WCAP-17236-NP, Rev. 0  
Project Number 694

Subject: Pressurized Water Reactor Owners Group  
**Responses to the NRC Request for Additional Information (RAI) on PWR Owners Group (PWROG) WCAP-17236-NP, Revision 0 "Risk Informed Extension of the Reactor Vessel Nozzle Inservice Inspection Interval" (TAC NO. ME4878) PA-MSC-0440**

Subject: Response to NRC Request for Additional Information and Mark-Up Pages for WCAP-17236-NP, Revision 0, "Risk-Informed Extension of the Reactor Vessel Nozzle Inservice Inspection Interval"

Figure DCI-RAI-2-2 – Flow Chart for Piping Weld Failure Modes (from Reference 4)

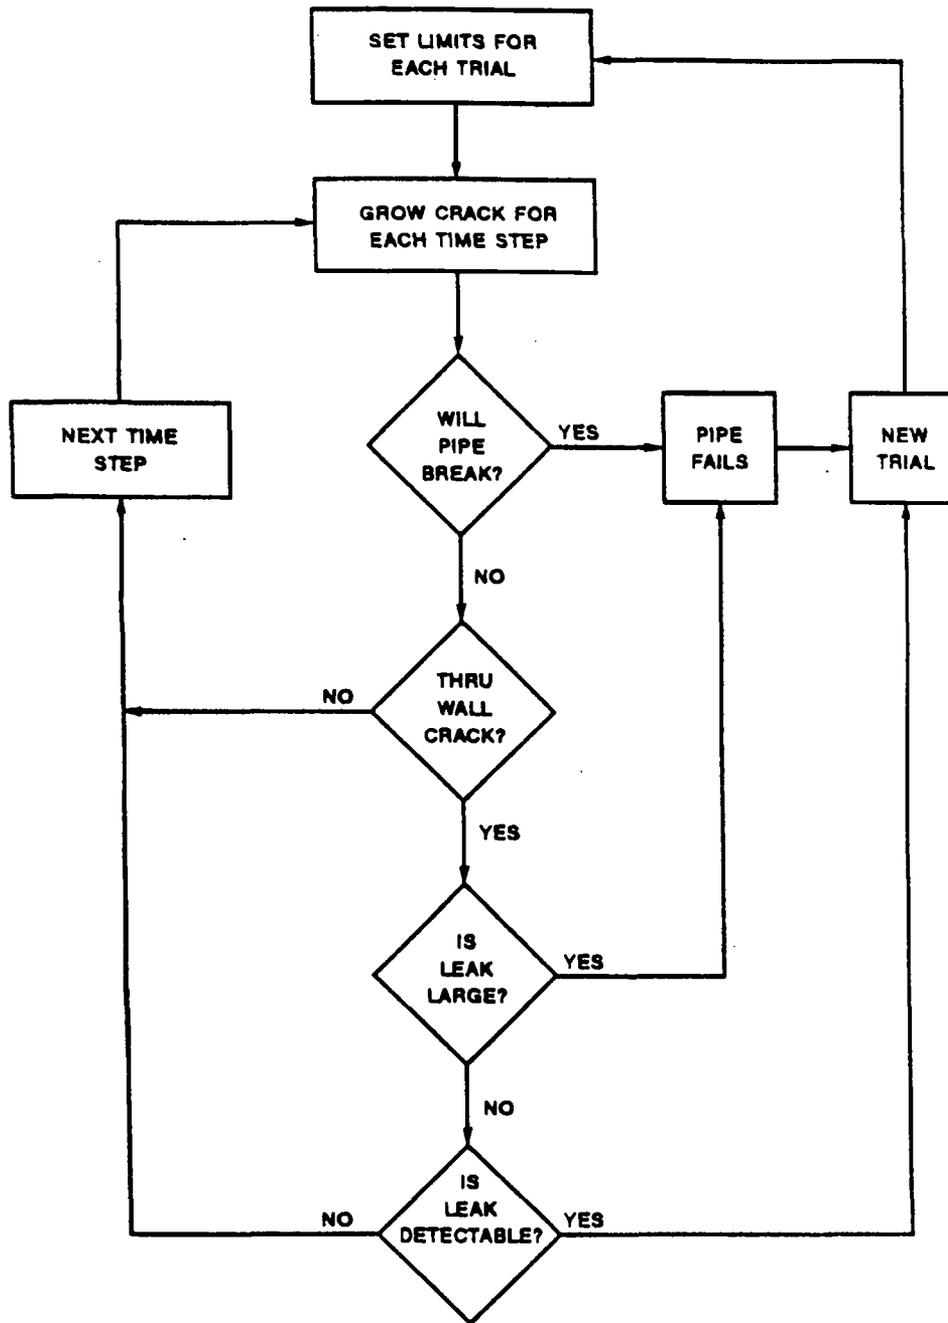
**DCI-RAI-2** *Section 2.4.1 of TR WCAP-17236 mentions that "the calculations are performed using the change in failure frequencies with credit for leak detection." Provide a summary of the PFM analysis methodology used in TR WCAP-17236, including:*

The PFM methodology used to calculate the change in failure frequencies with credit for leak detection is summarized as follows:

4. To calculate the failure probabilities for the failure modes of specified leak rates, such as a small-break loss-of-coolant accident (LOCA), a medium or large-break LOCA or the effects of leak detection on a full break due to ductile rupture, the pre-processor program CLVSQ is used. CLVSQ stands for crack length versus the leak flow Q, and typical calculated results are shown in Figure DCI-RAI-2-1 (Figure 2-4 in the SRRA Supplement, Reference 4). The crack flow rate, dQ/dt, in gallons per minute (GPM) is calculated in CLVSQ using the equation:
